**Rezoning Transportation Analysis**  
**Petition Number: Insert Zoning Petition #2021-214**  
*General Location Identifier: 11123345*

<b>Revision Log:</b>	<b>Date</b>	<b>Description</b>
	01-21-2022	First Review (AO)

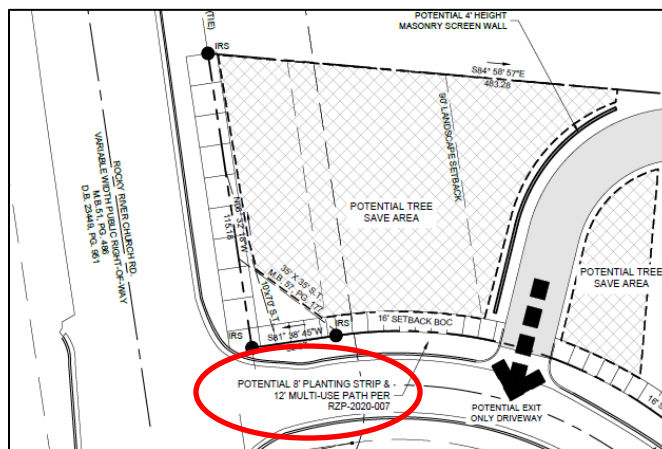
1. **Curbline:** The proposed zoning district has a setback measured from back of the existing or proposed future curblines.
  - a. **Rocky River Road:** Location of curb and gutter is in its existing location.
  - b. **Woodland Beaver Road:** Location of curb and gutter is in its existing location.

Label and dimension the curb and gutter from the centerline for each road on the site plan.

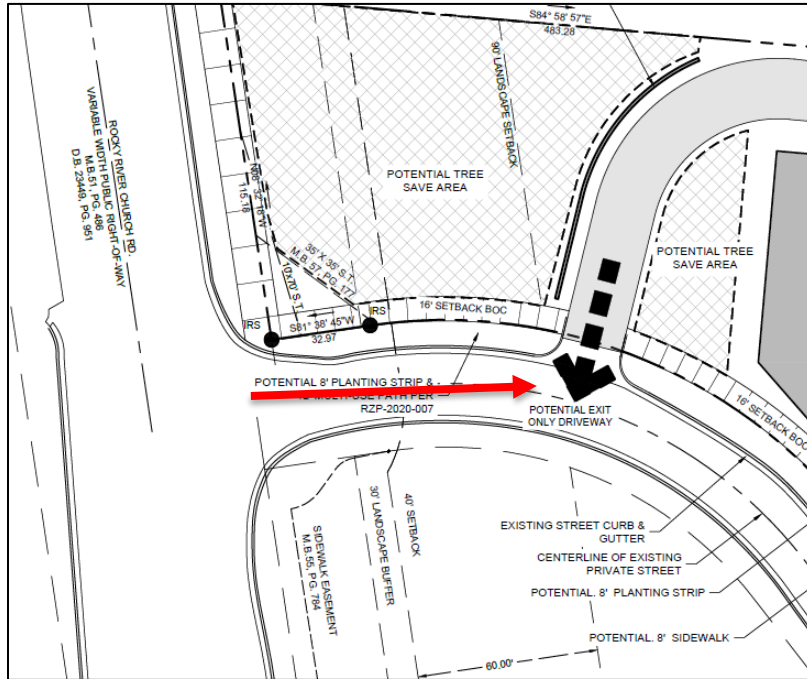
4. Revise site plan and conditional notes showing a minimum of 100' of separation from proposed egress access point of Woodland Beaver Road measured from right-of-way line from Rocky River Church Road.

Label and dimension from right-of-way line along Rocky River Church Road.
